SEISMIC MARGINS STUDY  
J. Kovic needs to review the portions of Attachment 2  
relative to UNITED STATES geotechnical engineering

NOTE FOR: George Lear, Chief SGEB  
THRU: P. T. Kuo, Section Leader, Section B, SGEB  
FROM: Frank Rinaldi, Structural Engineer, Section B, SGEB  
SUBJECT: MEETING SUMMARY - TERA's IDCVP

Re: Docket Nos. 50-329 OM, OL and 50-330 OM, OL  
Midland Nuclear Plant - Units 1 and 2  
Independent Design and Construction Verification (IDCV) Program  
Meeting Summary

130.30 With respect to Volume II, Seismic Margin Review: Reactor Containment Building, forwarded by your letter of March 30, 1983, provide the following information:

FIGURE Q&R 130.30.2-8. NSSS Loop Model

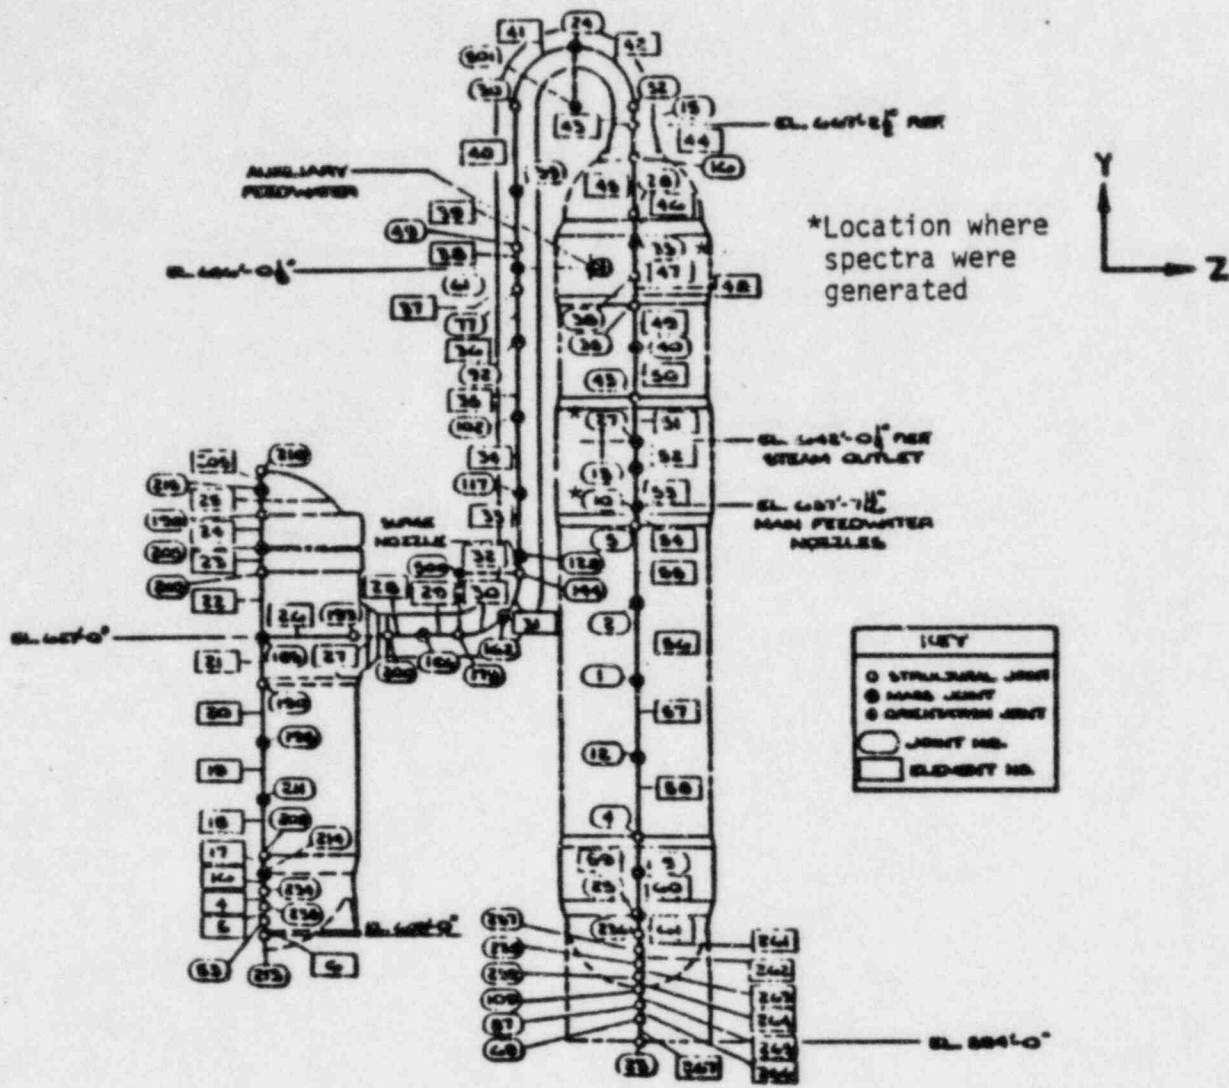
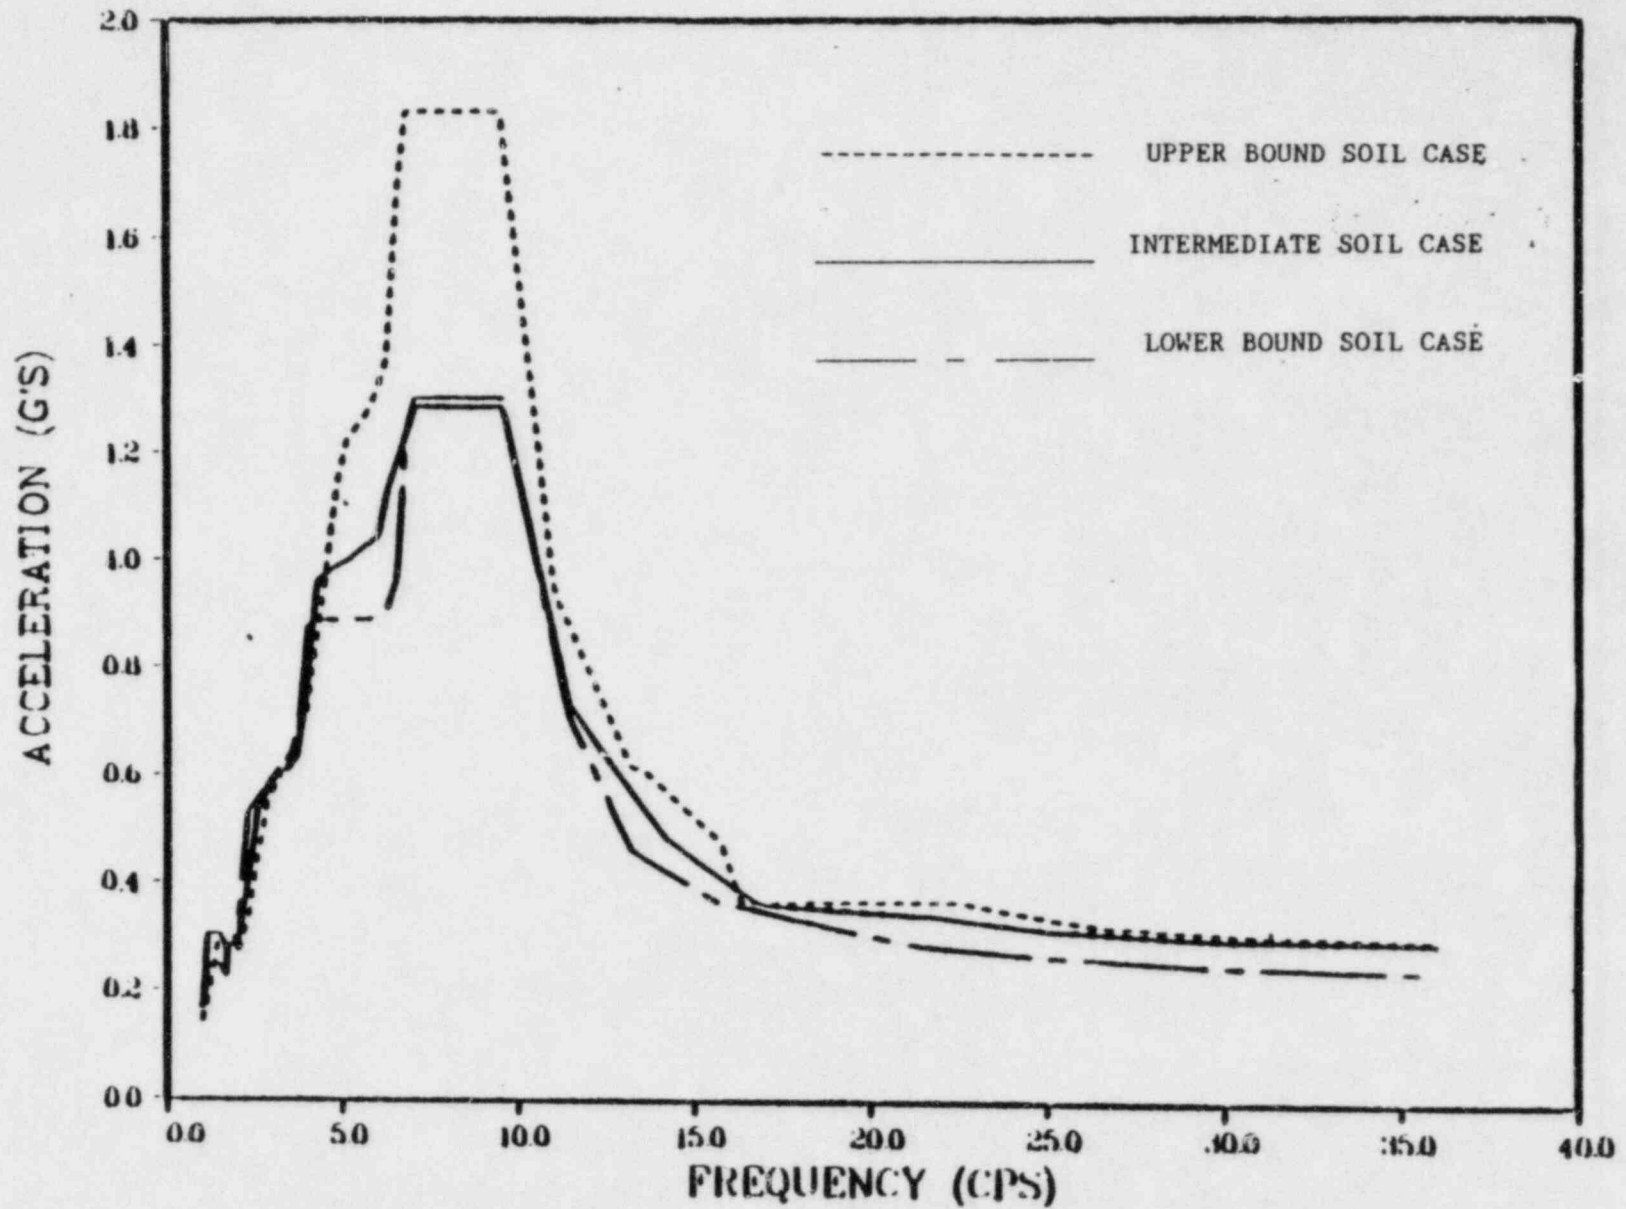
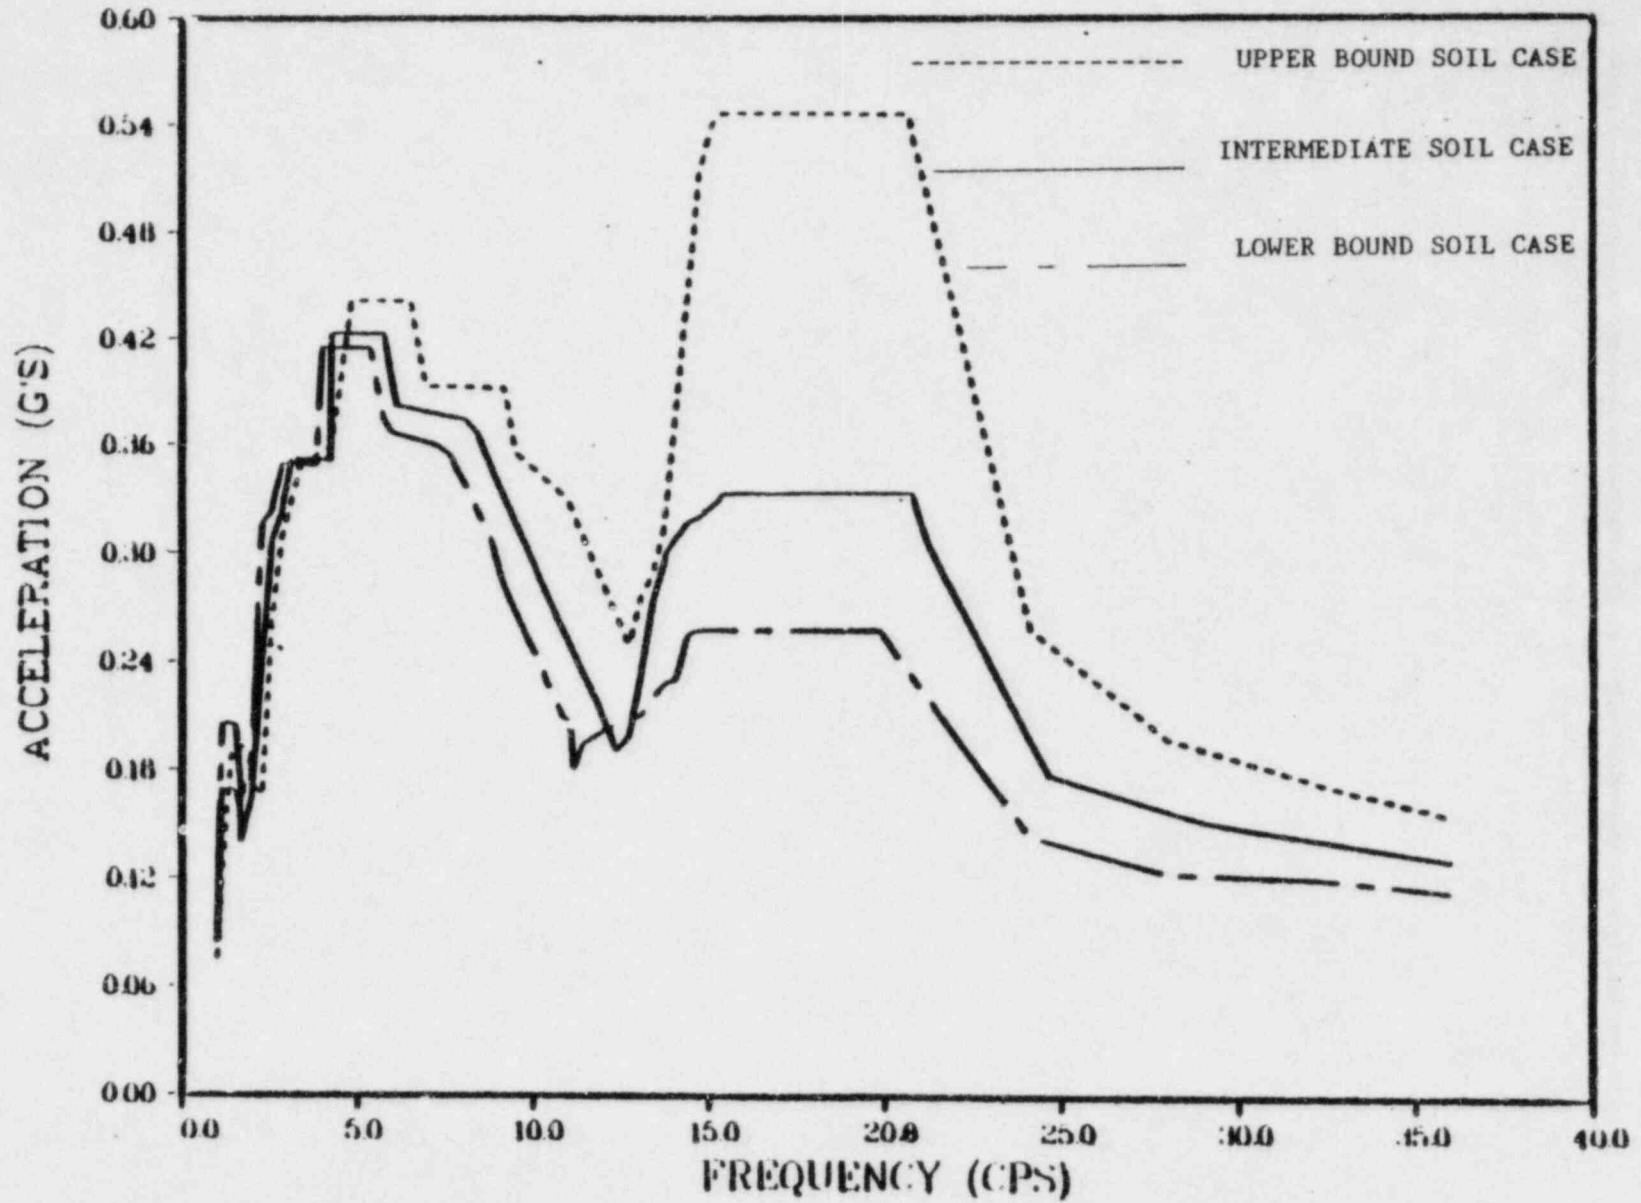
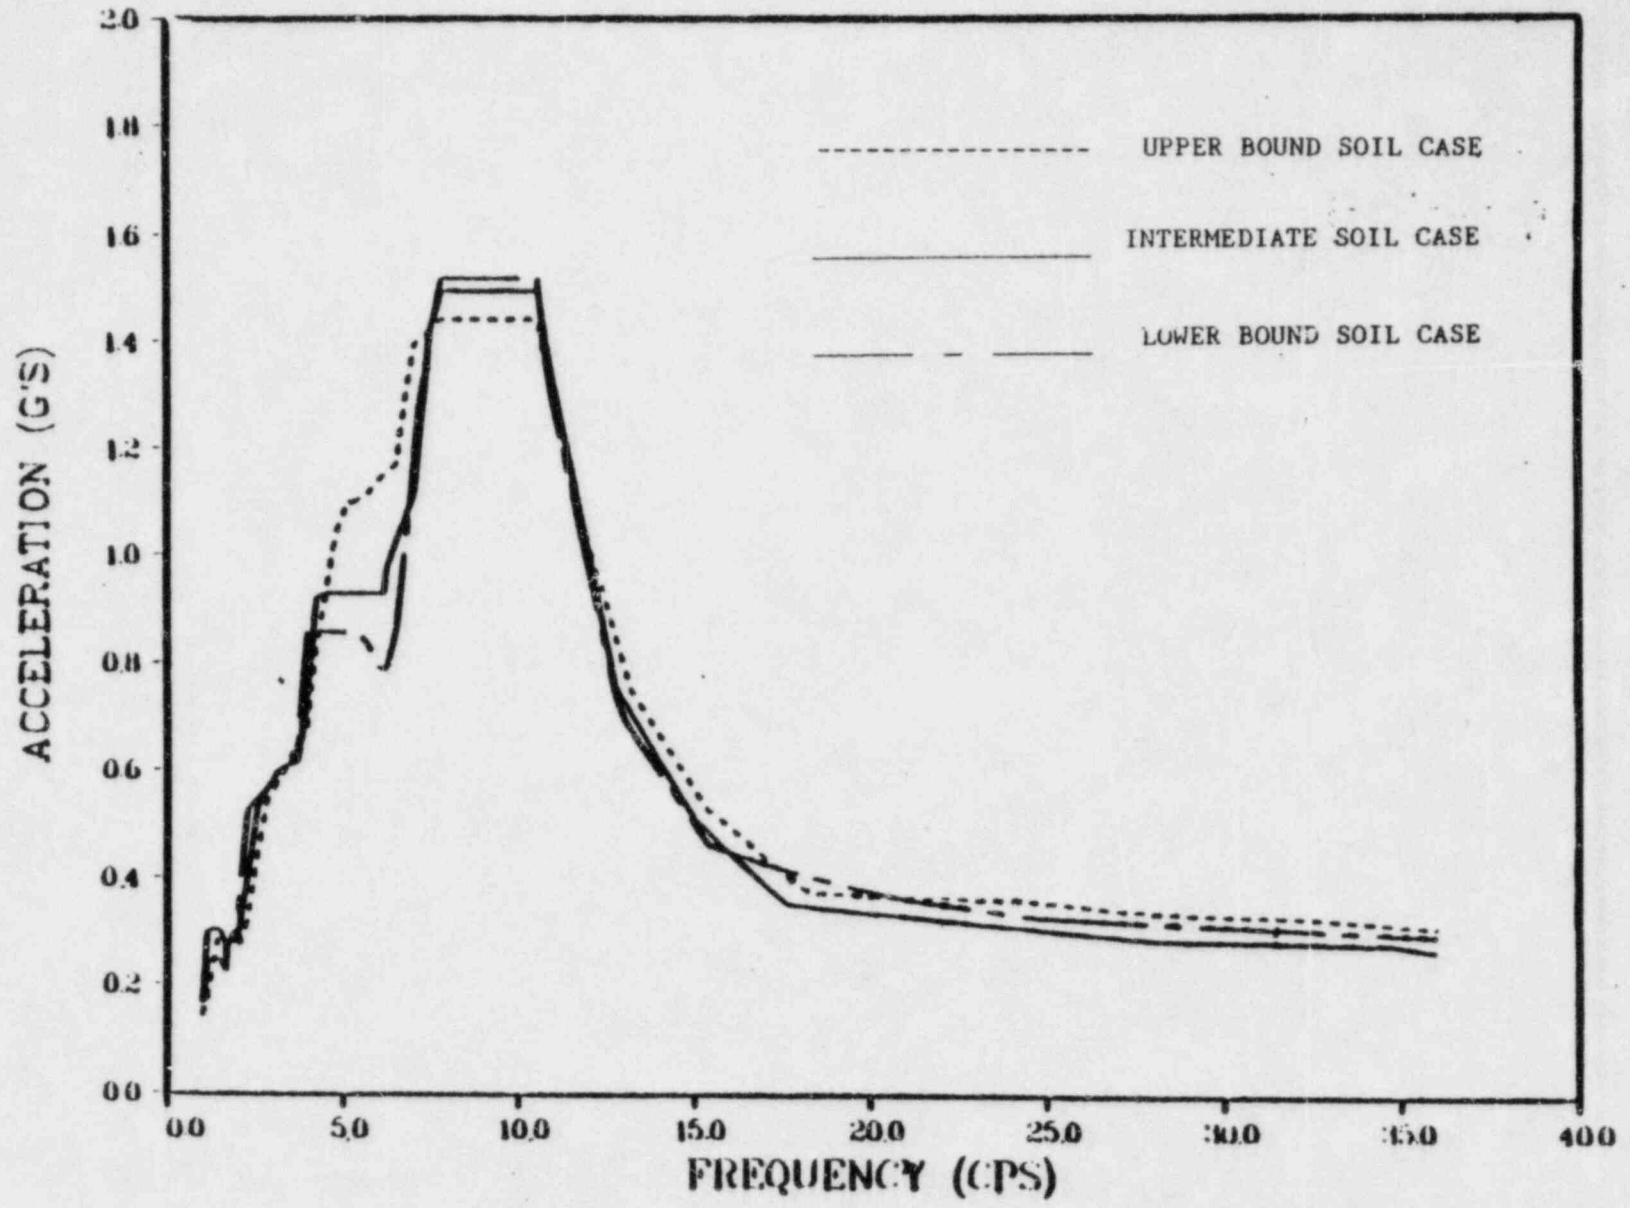
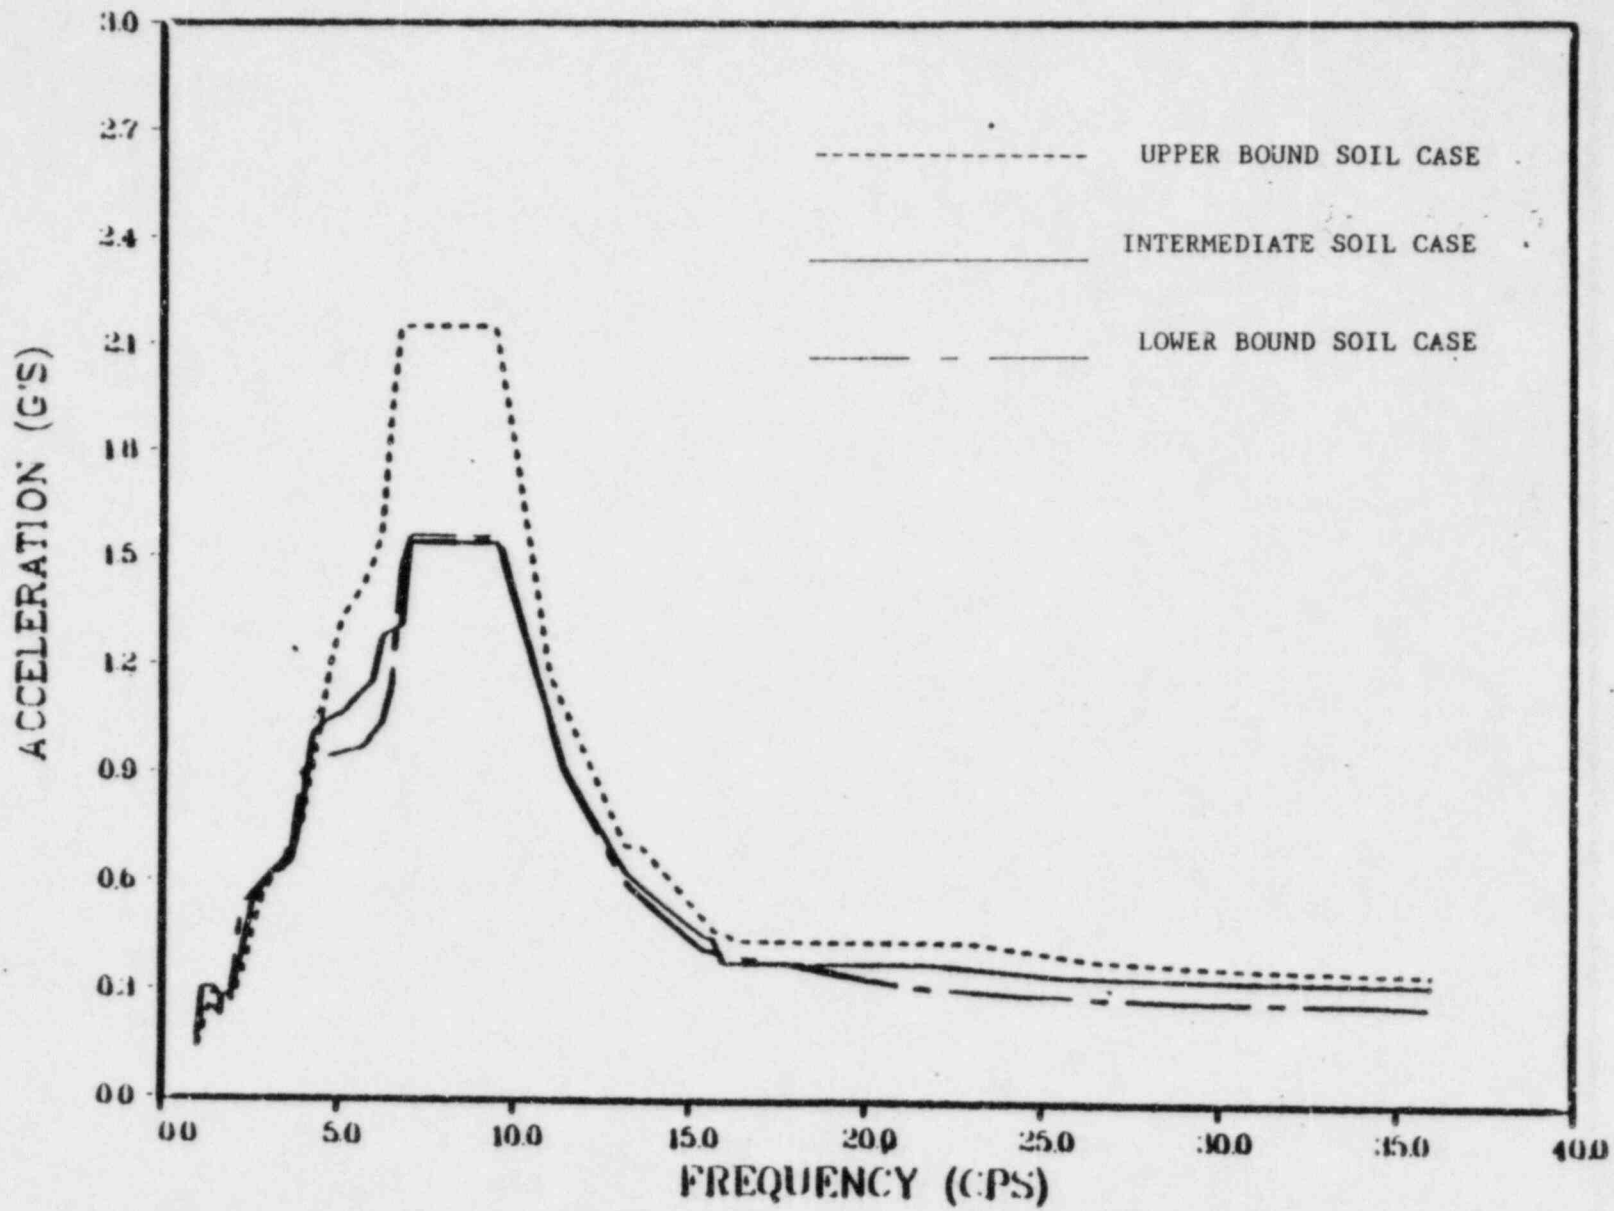
Section 5 of the report presents in-structure response spectra for internal structures. However, none are provided for the steam generators and the reactor vessel. Please provide these missing spectra or justify their omission.

Volume II was written to describe the analysis of the reactor containment buildings and their internal structures. In addition, Volume II presents the in-structure response spectra for use in evaluating equipment attached to the structure. Seismic input at the Nuclear Steam Supply System (NSSS) interfaces in the reactor containment buildings was developed by Structural Mechanics Associates, Inc. (SMA) for the Seismic Margin Earthquake. This input was defined in terms of translational and rotational time histories and response spectra for each of the three soil cases studied. The requested seismic response spectra were generated by Babcock & Wilcox (B&W), the NSSS Vendor. Since the B&W generated seismic response spectra are only an intermediate step in the Balance-of-Plant piping analysis, they were not included in Volume VIII. Figures Q&R 130.30.2-1 through Q&R 130.30.2-7 present the schematic of the reactor vessel model used by B&W and the seismic response spectra for 4 percent of critical damping. Similarly, Figures Q&R 130.30.2-8 through Q&R 130.30.2-17 are presented for the steam generators.
